Green Textile Limited (Unit-3)_Expansion

Nejhuri, Baraid Bazar, Bhaluka, Mymensingh
(24.446123, 90.338425)

24 May 2023

Observation: Canteen Building

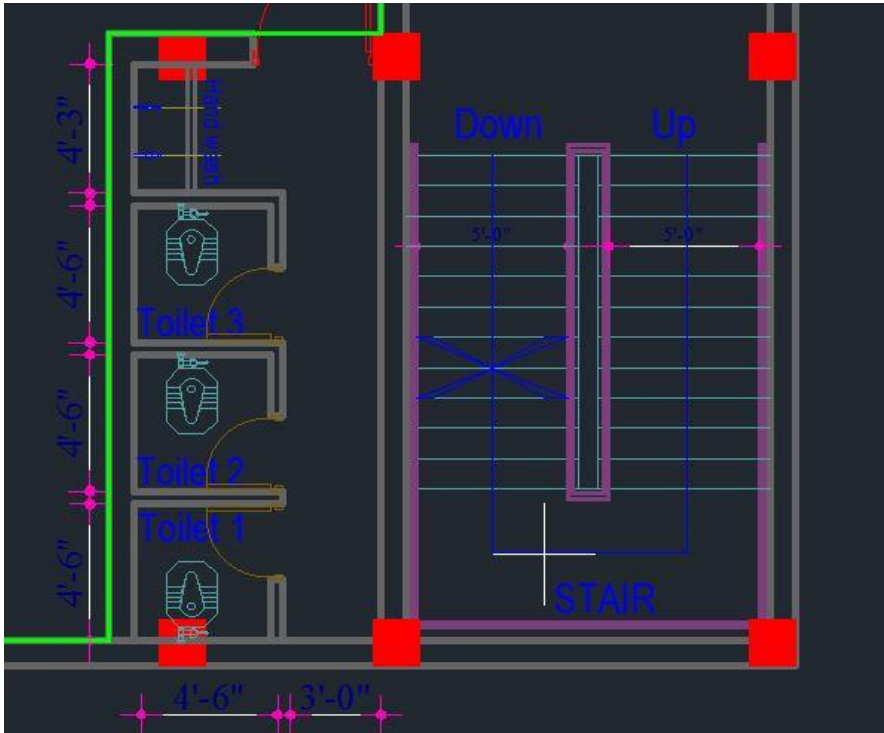
Discrepancy in as-built drawing

Floor build-up not shown in as-built drawing

200mm build up found at toilet area

200mm build up found at toilet area which was not shown in as-built drawing. Building engineer is required to survey the whole structure and update as-built drawing as per onsite condition.
